## INSTRUCTIONS TO PERFORM RECALL CAMPAIGN 170

Certain Model Year Winnebago 2020-2023 View and Navion (500-Series) Motorhomes. These motorhomes were manufactured from March 1, 2019, through October 13, 2022.

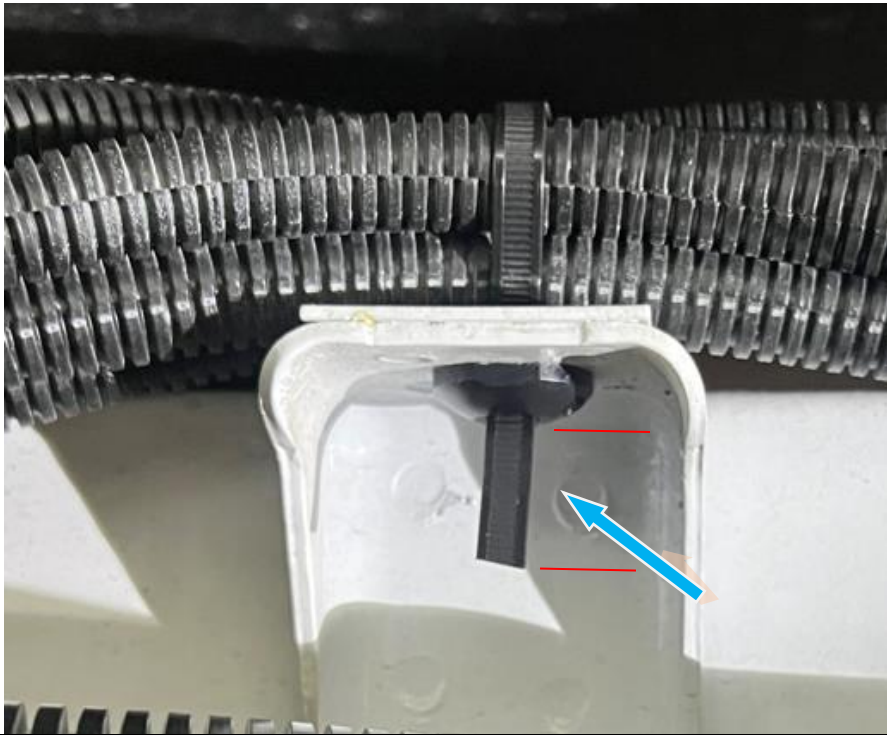
10. On the 524V, reuse the clamp previously removed to reattach the macerator line (Shown with the blue arrow). Note: The best practice is to keep the macerator line horizontal in this area to prevent excess trapping.

11. Trim off the excess tie leaving a 1" long tail. Make sure the button head tie is installed as shown and that it is properly wrapped around the L.P. line and system lines as shown.
